NRCB | Natural Resources Conservation Board

Application for Amendment

NRCB USE ONLY		NRCB Application number	Date Stamp
<input type="checkbox"/> Approval	<input type="checkbox"/> Registration	<input checked="" type="checkbox"/> Authorization	NRCB APPLICATION
		LA24004A	21 JUL 25
			RECEIVED

Combine Ems + catch basin to 45m x 45m x 6m deep
move over to 8m from east property line
Rcc feedlot pens.

Catch Basin Storage Volume Calculator

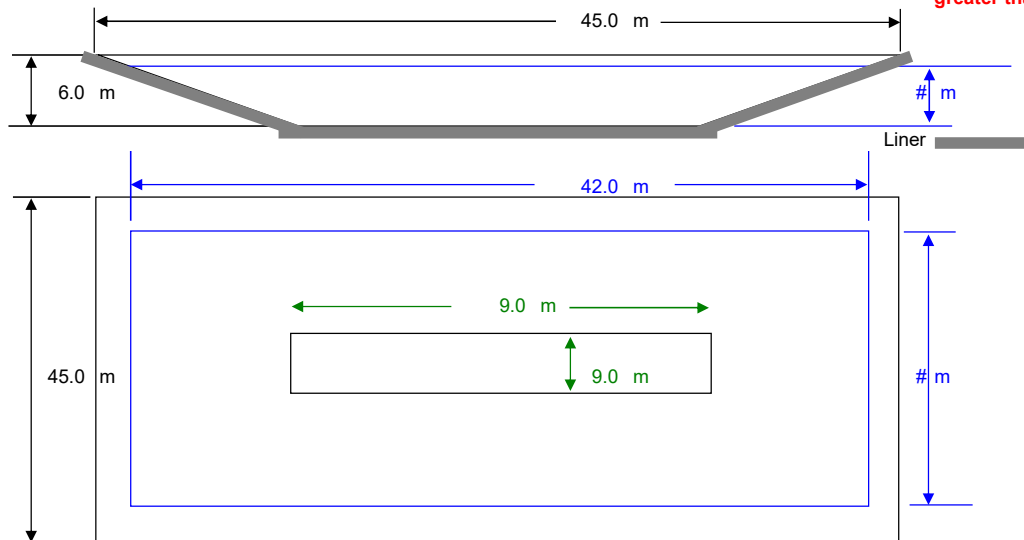
Authorization LA24004 permitted a catch basin (40 m x 25 m x 5 m deep) and an earthen liquid manure storage (EMS) (45 m x 40 m x 5 m deep). This application for amendment seeks to combine those facilities into one EMS that will also collect run off from the feedlot pens. The proposed dimensions of this facility are 45 m x 45 m x 6 m deep. The proposed location is approximately 20 m east of the originally permitted location. No changes to the naturally occurring layer are proposed with this application.

Total Length* ₄	45.0 m
Total Width* ₄	45.0 m
Total Depth* ₄	6.0 m
Design Capacity Depth	5.50 m
End Slope* ₄	3 run:rise
Side Slope* ₄	3 run:rise
Length of Bottom	9.0 m
Width of Bottom	9.0 m

Design Capacity (freeboard level) 4,076 m³

1,469 m³ **
